Project	IEEE 802.20 Working Group on Mobile Broadband Wireless Access	
Title	Updated Text for 802.20 Minimum Performance Specification – Wideband Mode	
Date Submitted	2008-11-07	
Source(s)	Jim Tomcik Qualcomm Incorporated 5775 Morehouse Drive San Diego, CA, 92121	Voice: 858-658-3231 Fax: 858-658-2113 Email: jtomcik@qualcomm.com
Re:	IEEE 802.20 MPS Docuemnt – Wideband Mode	
Abstract	This contribution updates the previously contributed documents on Minimum Performance for the 802.20 Wideband Mode. It incorporates edits and discussion points from the September, 2008 meeting of 802.20 in one consolidated document.	
Purpose	Review and acceptance of the text as the Wideband Mode portion of the 802.20 Minimum Performance Specification.	
Notice	This document has been prepared to assist the IEEE 802.20 Working Group. It is offered as a basis for discussion and is not binding on the contributing individual(s) or organization(s). The material in this document is subject to change in form and content after further study. The contributor(s) reserve(s) the right to add, amend or withdraw material contained herein.

Figure 43: Functional Setup for Access Network Intermodulation Spurious Response Tests

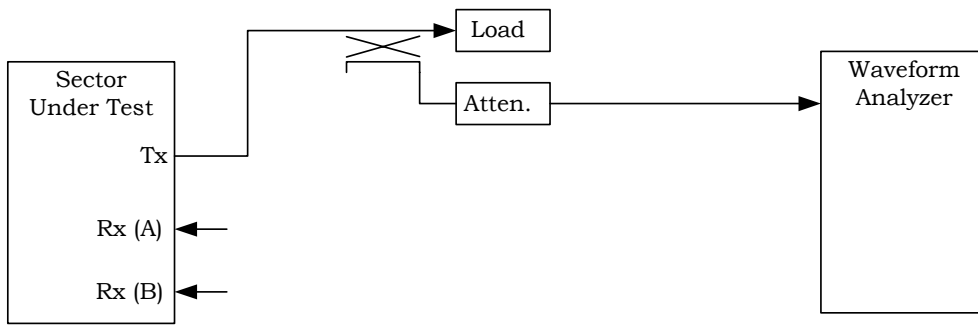
<N. B. Figure has been Edited>

Figure 87. Functional Set-up for Test for Adjacent Channel Selectivity

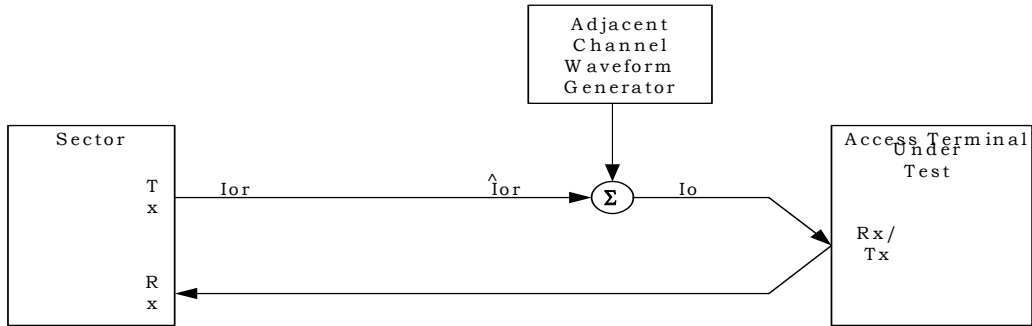
<N.B. Figure has been edited>
